environmental review team report

PINE HILL ESTATES
SUBDIVISION
COLUMBIA, CONNECTICUT

ENVIRONMENTAL REVIEW TEAM REPORT
ON
PINE HILL ESTATES
COLUMBIA, CONNECTICUT
MAY, 1976

TOPOGRAPHY AND BEDROCK GEOLOGY

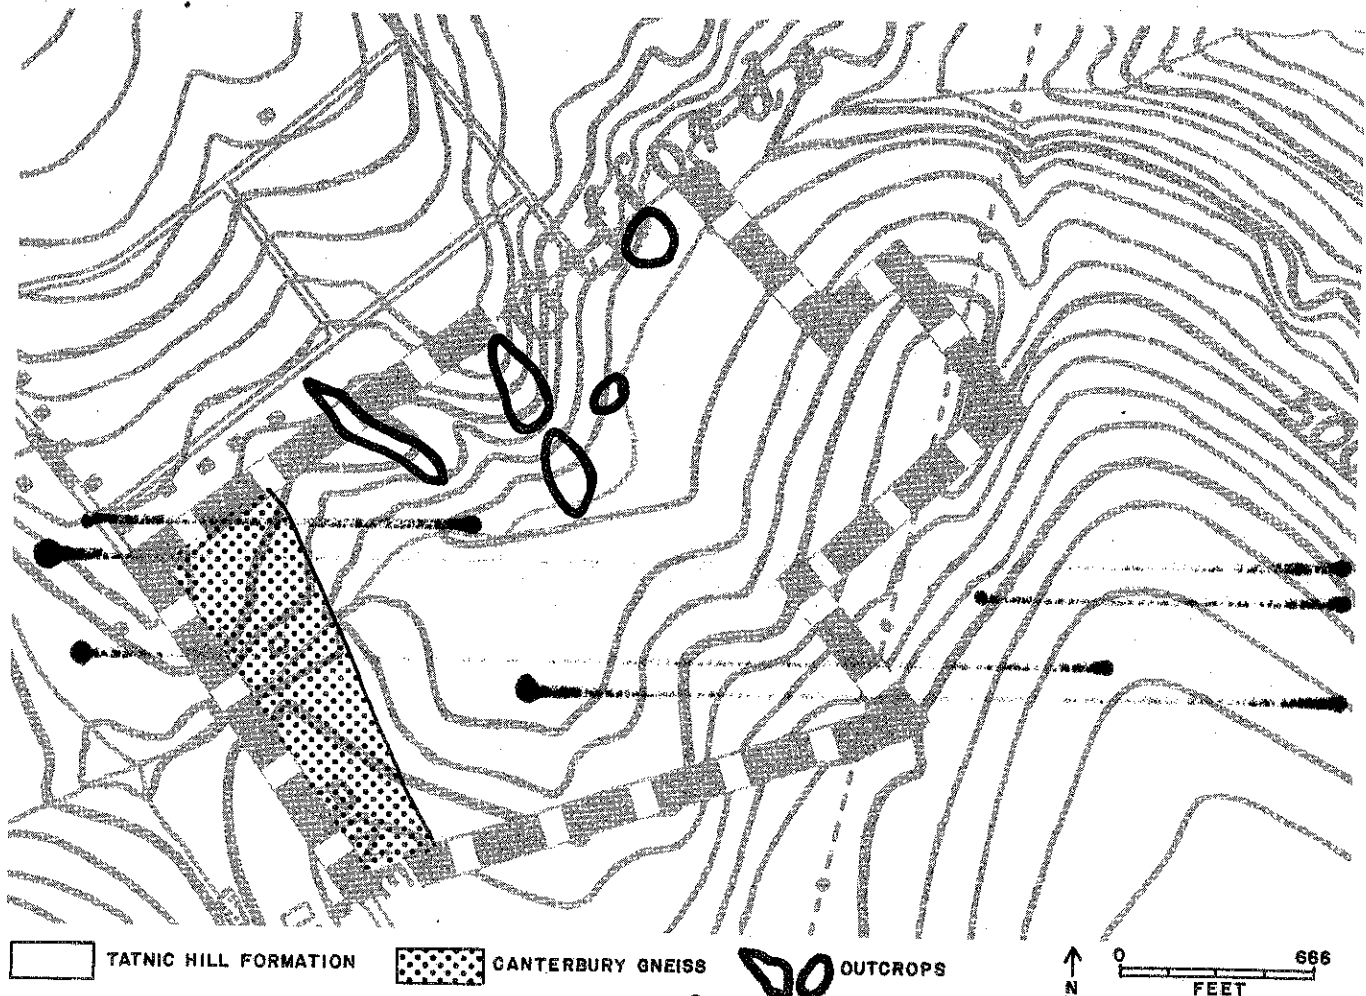
The Canterbury Gneiss covers approximately one sixth of the site paralleling Pine Street. Its grains are medium with a gray to white color. The composition is oligoclase-orthoclase-quartz-biotite-granodiorite gneiss. It commonly makes long hillside ledges with broad hilltop exposures. Evidence of such exposures were observed on the northwest side of Gifford Brook (see topography and bedrock geology map).

DRAINAGE AREA

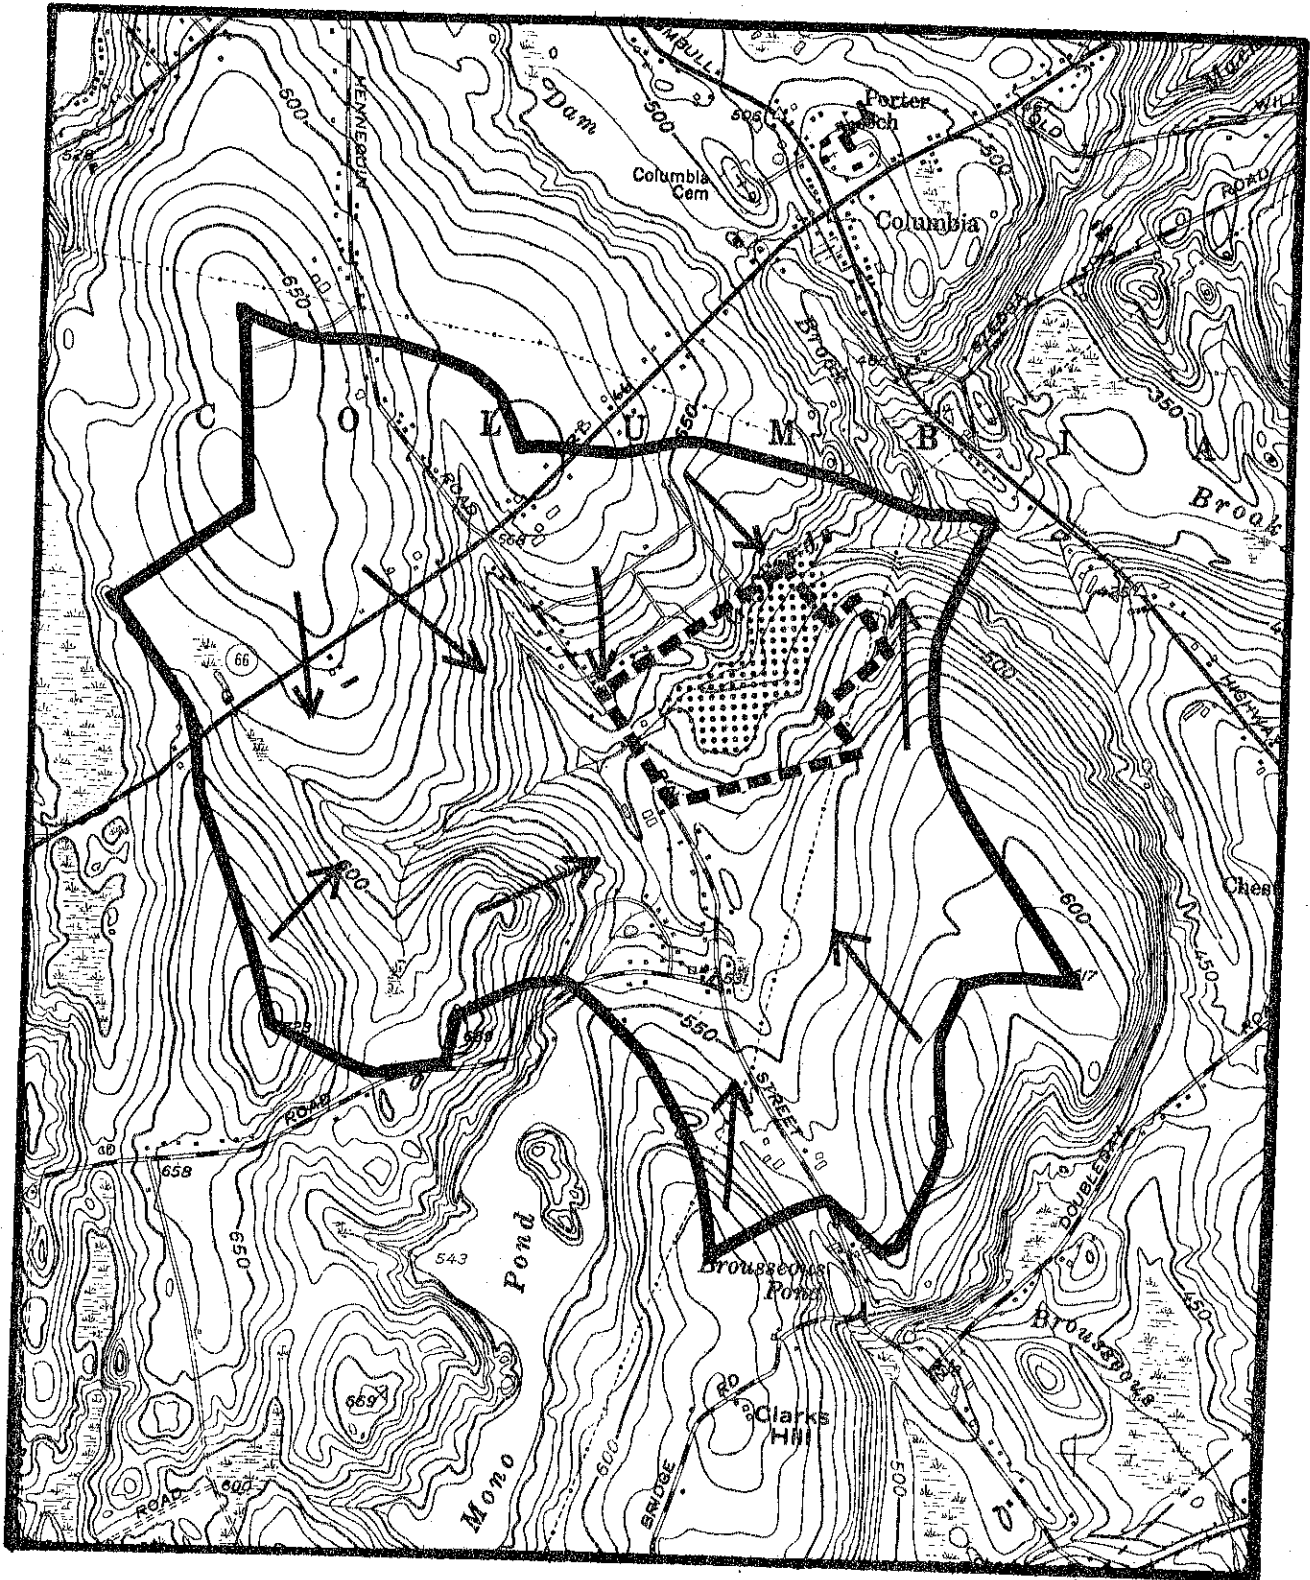
The proposed site is located near the outlet of the Gifford Brook drainage basin. The basin comprises approximately 2.61 square miles. Gifford's Brook and the watershed, the largest drainage area in Columbia, is located entirely within the Town (see Drainage Areas map).

The ground water flow for the site is generally similar to that of the surface water shown in the Drainage Area map. The site's unconsolidated materials are composed mainly of till, indicating slow movement of ground water. This slow movement is evidenced by the numerous intermittent streams found in the area, indicative of poor drainage.

The Streambelt Report for Columbia indicates that ~~approximately 1,000 feet upstream from the confluence of Gifford's Brook and the Tenmile River and northeast of Connecticut Route 87,~~ the topography and soils of the brook valley appear favorable for creating a moderately deep pond of up to 55 acres. Refer to Drainage Area map. ~~Extent of impounding would be limited by agricultural use of the brook valley land and the low elevation of Route 87.~~ The site has potential for a water supply, recreation, boating, fishing, and a wildlife pond.

FLOOD PRONE AREA

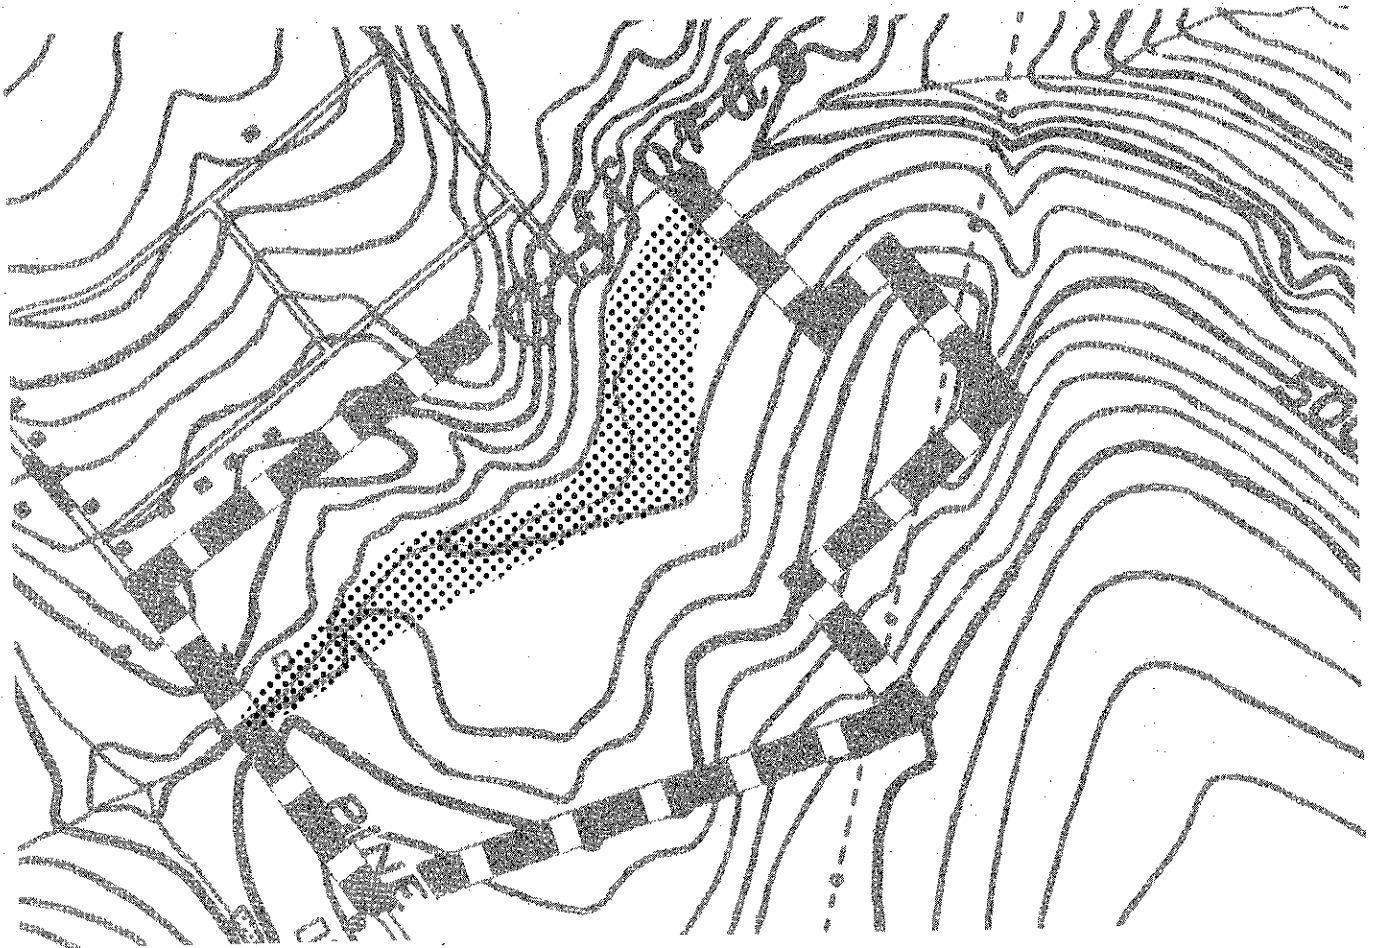
The main channel of the drainage area flows through the center of the site. A flood prone area does exist along the brook (see flood prone area map). According to source material from the United States Geologic Survey (USGS), the area indicated as flood prone has a one in 100 years recurrence level, meaning that at least once in 100 years the flood water will reach the level indicated. Of course, it should also be noted that this is a statistical flood level and that the levels indicated can occur twice in one year or for two successive years or more. A study of soils types will give a good indication as to normal yearly flooding. For safety, the one in 100 years flood level should be used for all design plans.

SOIL MAP

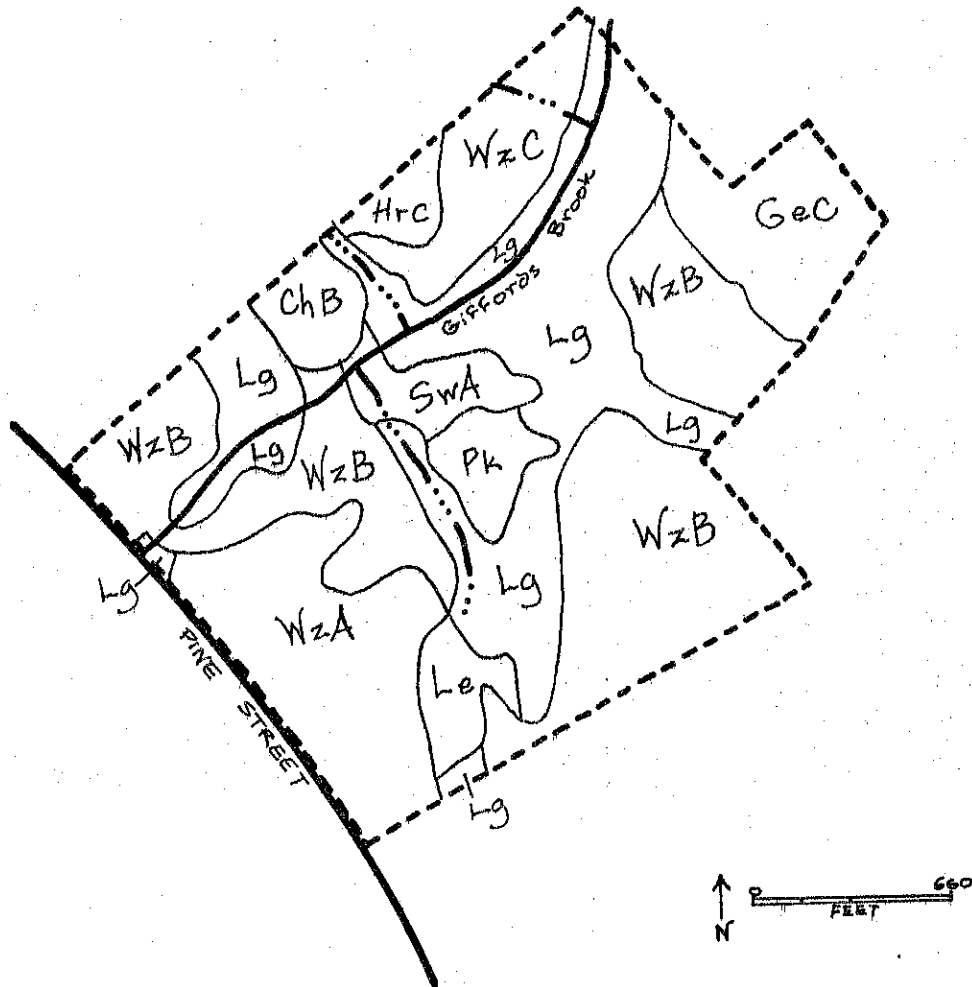
the map is an enlargement from the original 1,320'/inch to 660'/inch scale, the soil boundary lines shown should not be viewed as absolute boundaries but rather as guidelines to the distribution of soil types on the property. The soils map, along with the Soil Survey report, Tolland County, (USDA, SCS, 1966), can serve as an educational tool regarding the identification and interpretation of soils.

Along Pine Street where the first five lots are proposed there are three soil types present. There are approximately 30 acres of a Woodbridge soil type, mapping unit WZB. Lot one is proposed in this soil type. The Woodbridge series consists of moderately well drained soils that have formed over glacial till deposits derived mainly from schist and gneiss. The soils have a hard, compact layer at a depth of 20 to 30 inches. This layer is difficult to dig with a spade, but it crumbles readily in the hand when disturbed. This compact layer is sandy loam or fine sandy loam. Water passes through it slowly.

Lot one is proposed in Woodbridge soil mapping unit WZB. This is a very stony, fine sandy loam soil, with a gently sloping (3-8% grade) topography.

Lot 2 also includes a portion of the Leicester, Ridgebury, Whitman (very stony complex) soil type, mapping unit Lg. This soil type is made up of poorly drained Leicester and Ridgebury and poorly drained Whitman soils. The three soils occur in such an intricate pattern that it is not feasible to map them separately. All these soils are wet and very stony. They are nearly level or very gently sloping. Because of wetness and stoniness, they are used mainly for forestry, wildlife habitat, and unimproved pasture. Soil type Lg makes up approximately 25 acres of the site, surrounding Giffords Brook and its tributaries.

Lots 3, 4, and 5 are proposed in Woodbridge soil mapping unit WZA. It is largely a forest soil type. Scattered areas have been cleared and are used as unimproved pasture but is generally too stony for cultivated crops.
